CERTIFICATE OF APPROPRIATENESS

Property: 817 Columbia, Lot 8, Block 250, Houston Heights South Neighborhood Subdivision. The property includes a contributing 1,538 sq. ft. one-story residential building, situated on a 6,600 square foot interior lot.

Proposal: Alteration – The applicant proposes to add a two-story addition to the rear of the existing house. There is no proposed demolition or modifications to the detached garages.

PROPOSED ROOF PLAN

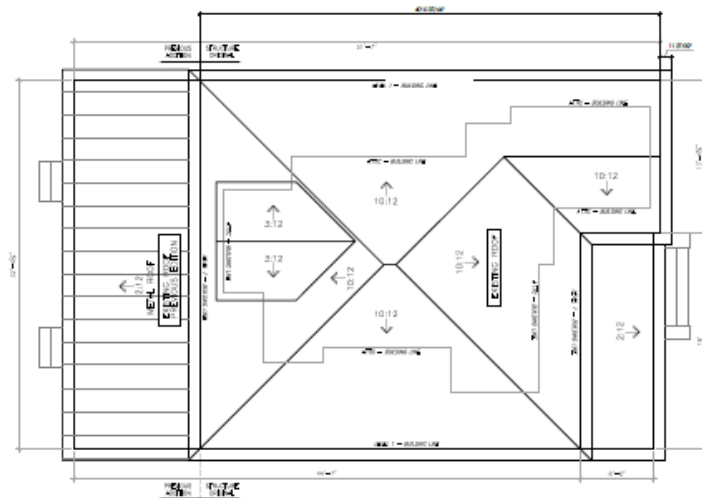
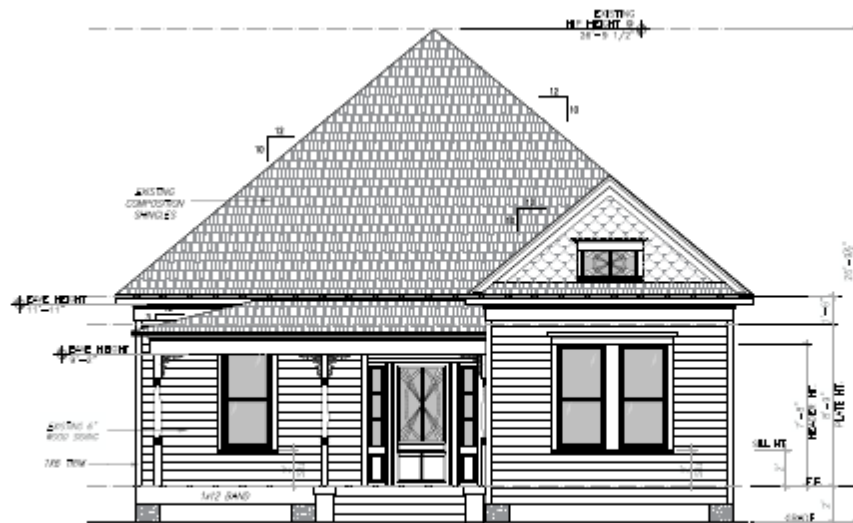
Recommendation: Approval with conditions: to lower the roofline of the connecting roof between the original house and the two story addition a minimum of two feet.
